Access Compliance Report

Public Rights-of-Way

Intersection ID: 29629	Main Street: WINGET_RD	Cross Street: PLANTERS_ESTATES_DR	Location: SE
ADA ID: EF78B4C92BC5	Ramp Type: PerpDiag	Initial Pass/Fail: Fail	Overall Compliance: No
Codes/Mitigation Info/Possible Solution		Field Measurements/Component Compliance	
Severity Score: 8.75

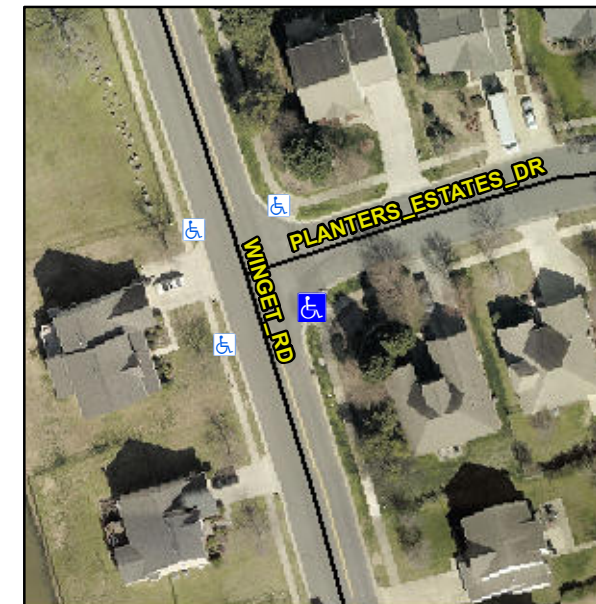
Remove & Replace Curb Ramp With Two New Directional Ramps or Equivalent.

Not Found, R304.5.1
